S E R V I C E N O T E

**4142B Modular DC Source/Monitor**

**HCU's current compliance may occur unexpectedly.**

Figure 1. ROM Locations

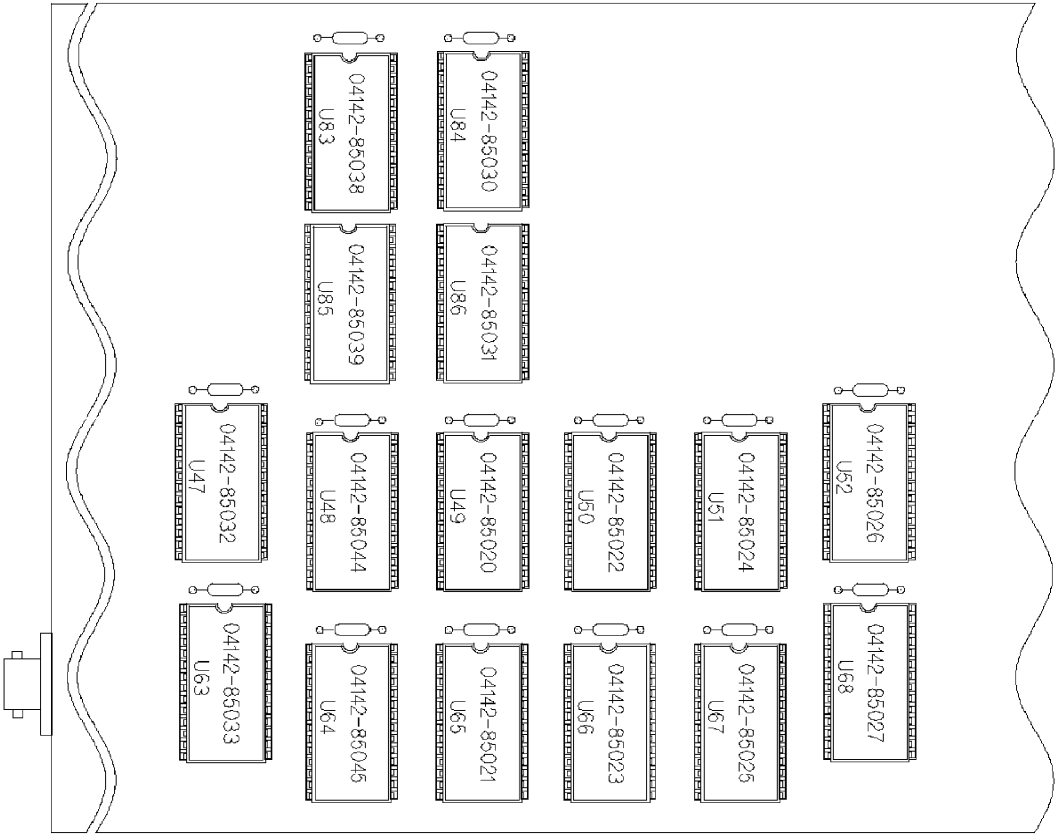
The problem may occur on the 4142B with the High Current Unit (HCU). The firmware revision is 3.0, 3.1, 4.0, or 4.1.

- Current compliance occurs on the HCU that is NOT used for the measurement. (The 4142B returns the measurement data status "Another channel reaches compliance" or "Txx".)
- The symptom occurs after the Self-Calibration only and does NOT occur after the Self-Test.
- The symptom may disappear by replacing the HCU.

If the above phenomena are verified, update the 4142B's firmware revision to 4.2 by replacing ROMs. (Do NOT replace the HCU at the beginning).

1. Turn the 4142B off and wait at least ten seconds.
2. Remove the CPU module from the 4142B mainframe.
3. Remove the side panel of the CPU module.
4. Remove the ROMs per the above table. For example, if the current revision is 4.1, remove U48 and U64. If the current revision is 3.0 or 3.1, remove all (16) ROMs. See Figure 1 for the ROM locations.
5. Place the new ROMs.
6. Reinstall the side panel of the CPU module, and reinstall the CPU module in the 4142B.
7. Turn the 4142B on. Confirm that no error appears in the ERROR/FAILURE display of the 4142B front panel.
